SUBJECT: Forwards addl info re pressure shielding steel diaphragm,  
 in response to questions raised during review of 790517  
 submittal.

Subject: Pressure Shielding Steel Diaphragm  
R.E. Ginna Nuclear Power Plant  
Docket No. 50-244

This letter is in response to questions raised by members of your Staff during the course of their review of our submittal dated May 17, 1979. The questions and responses are provided below.

R.E. Ginna - Figure 1  
Turbine Building Pressurization - 24" Main Steam  
Calculated Differential Pressure vs Time  
Mezzanine Level - Environment  
Initial Conditions:  $T_0 = 120^\circ\text{F}$   
 $RH = 5\%$

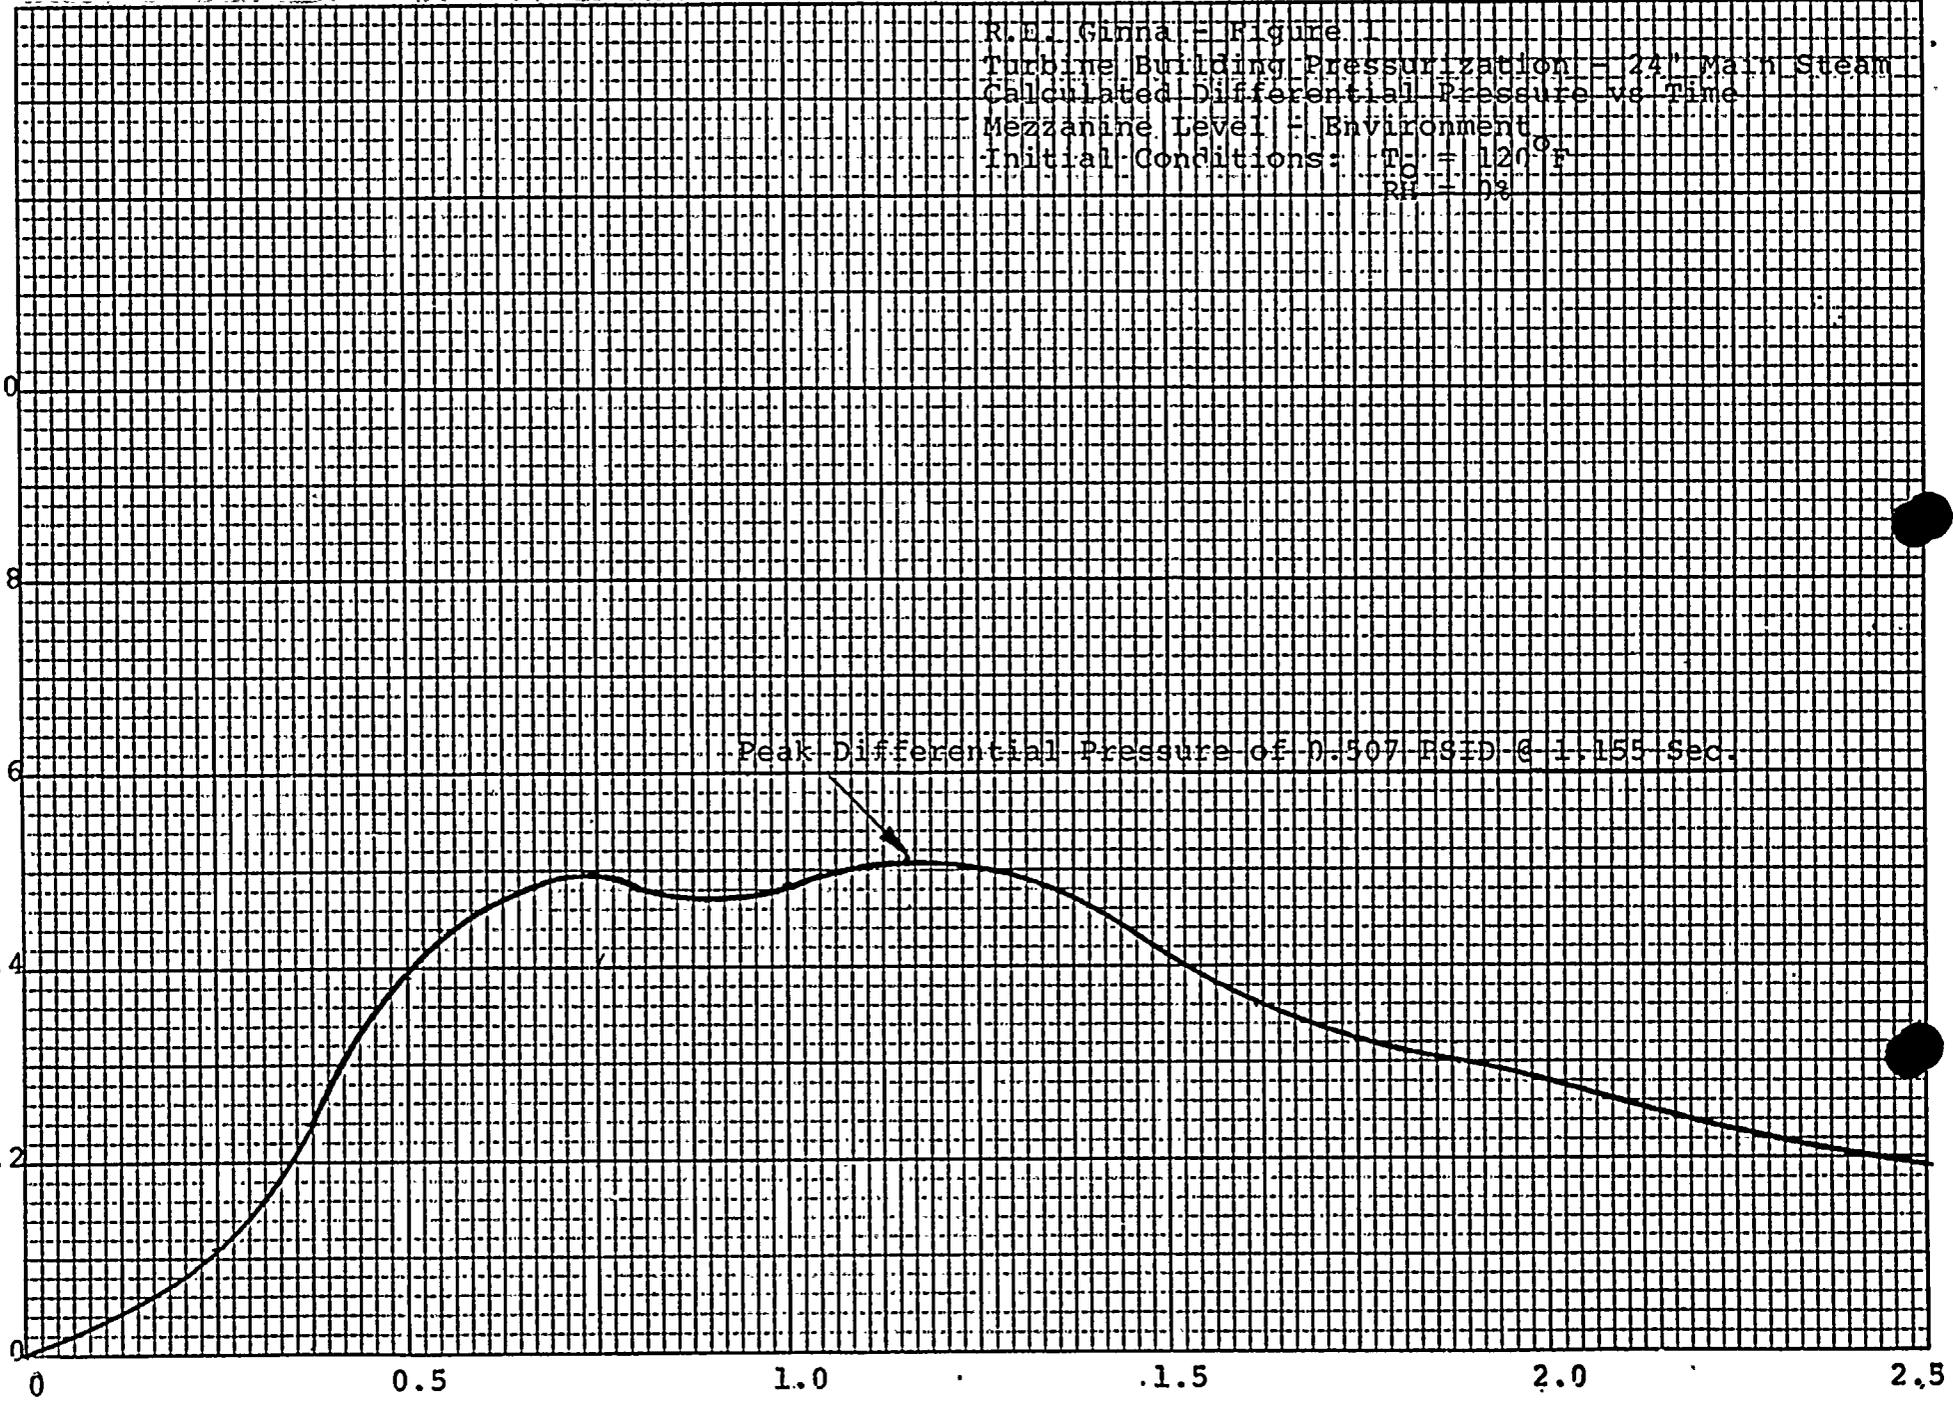
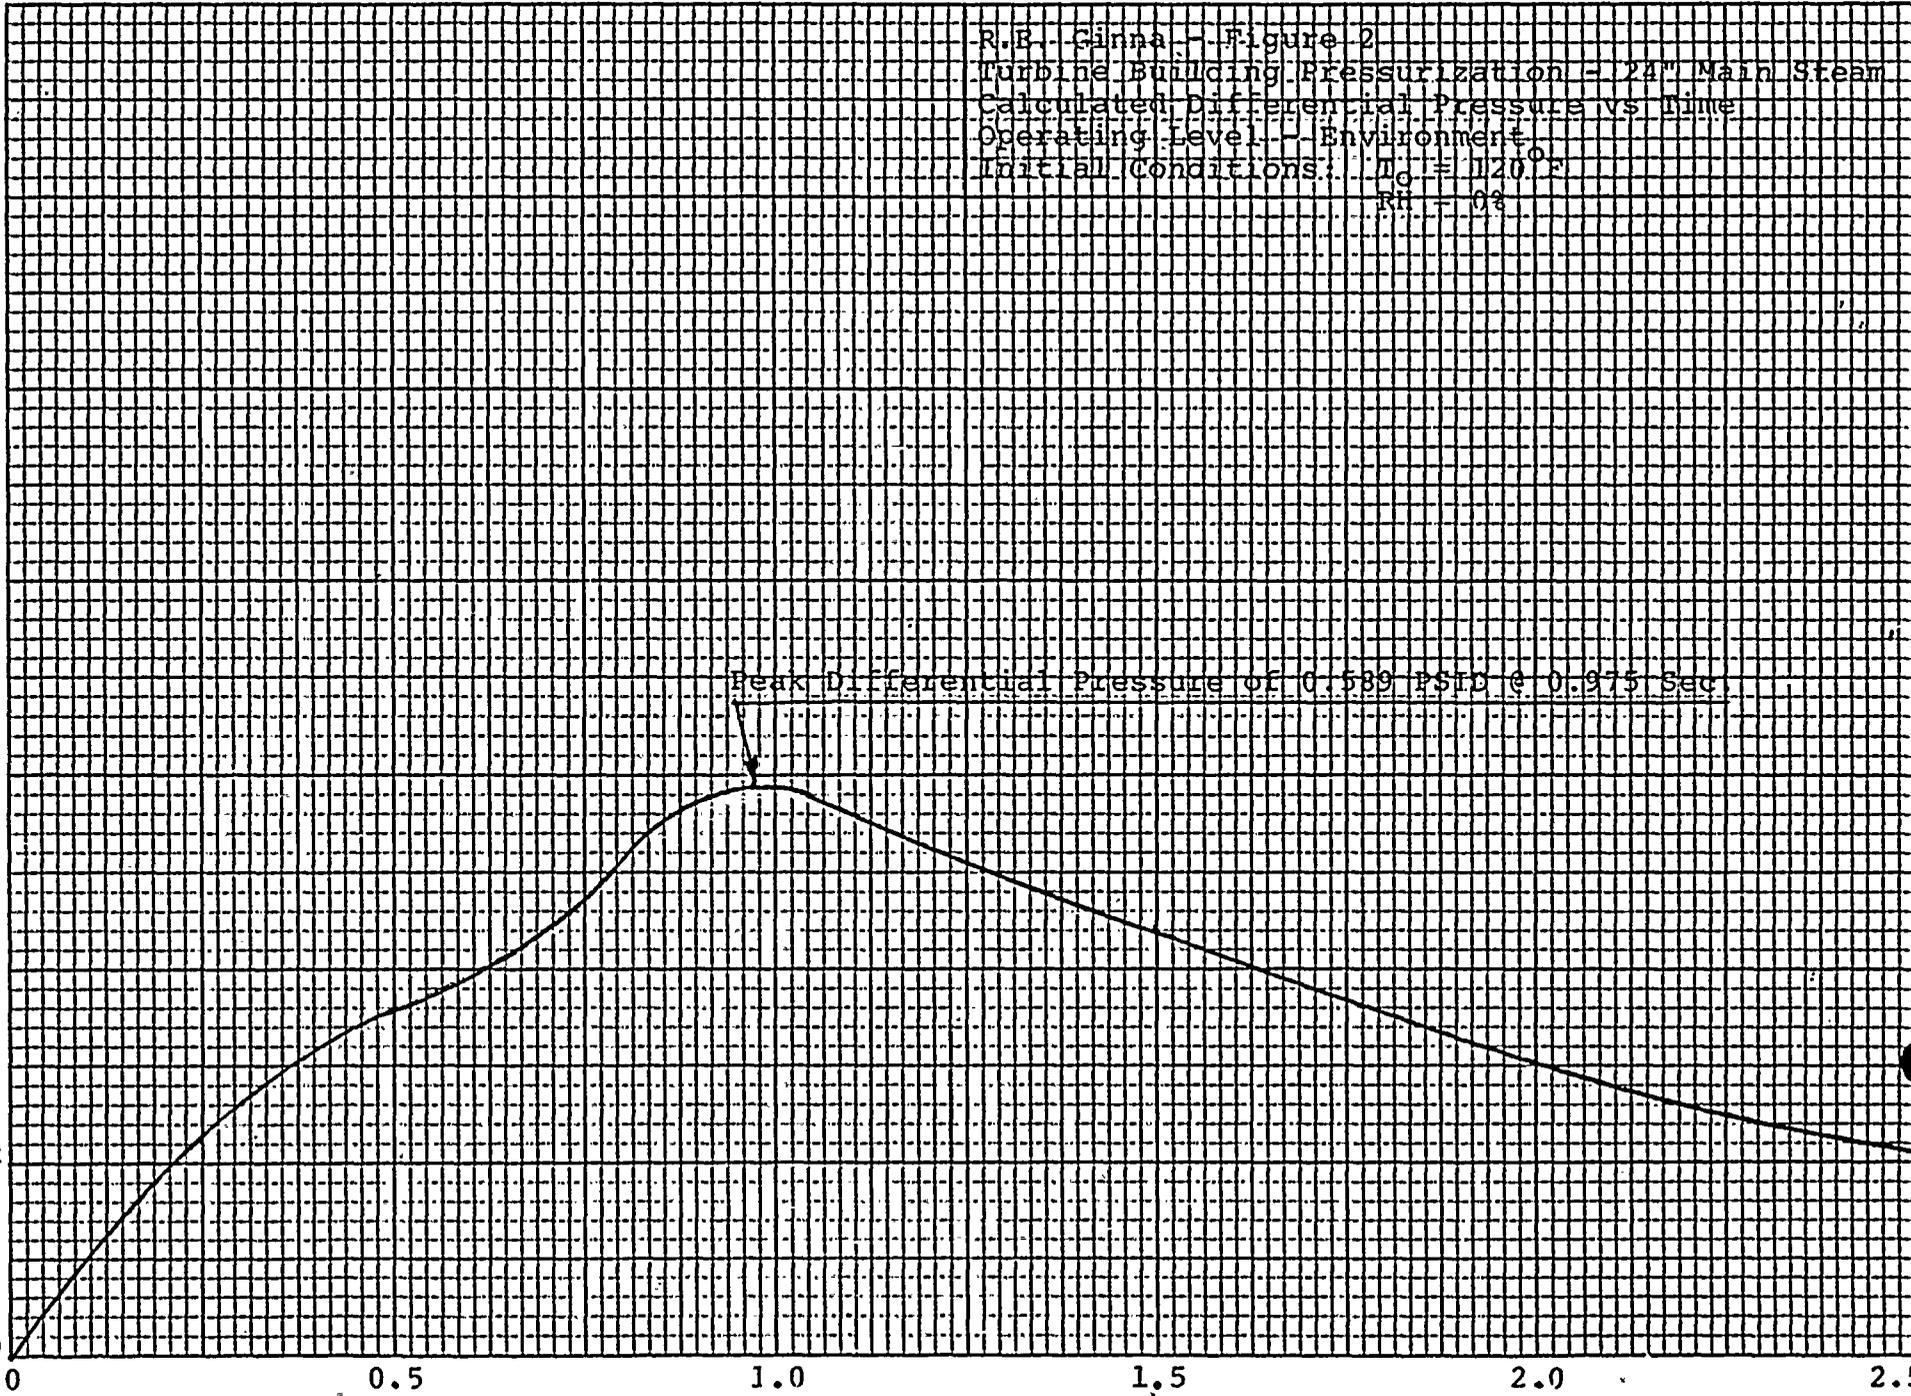
Members of your Staff requested that we investigate the consequences of an instantaneous double-ended guillotine break in either the 24" or the 36" main steam lines in the turbine building. This request was made recognizing that such breaks are precluded by the augmented inservice inspection program which has previously

been reviewed and approved by the NRC Staff. Nonetheless, the two breaks have been analyzed. The peak pressures on the mezzanine and operating levels from a 24" steam line break on the operating level are 0.507 psid and 0.589 psid respectively. The results for the 36" main steam line break on the mezzanine level for the mezzanine and operating levels are 1.264 psid and 0.742 psid, respectively. Curves of pressure vs. time for these two breaks are provided in Enclosure II to this letter. In the calculation of the pressure transient following a 24" steam line break, credit was taken for failure of a section of block wall as described and justified in our letter of May 17, 1979. In the calculation of the pressure transient resulting from a 36" steam line break, credit was taken for failure of the block wall and for failure of the building exterior siding. The exterior siding will fail at a pressure of 0.93 psi. This failure pressure is based on consideration of the siding design and method of attachment to the building and is set as the ultimate capacity of the aluminum panels in tension. A total of 2166 ft<sup>2</sup> on the mezzanine/basement elevations is assumed to fail. Since the pressure on the operating level for the 36" steam line break does not reach 0.93 psi, the siding at that elevation is assumed to remain in place.

Peak Differential Pressure of 0.507 PSID @ 1.155 Sec.
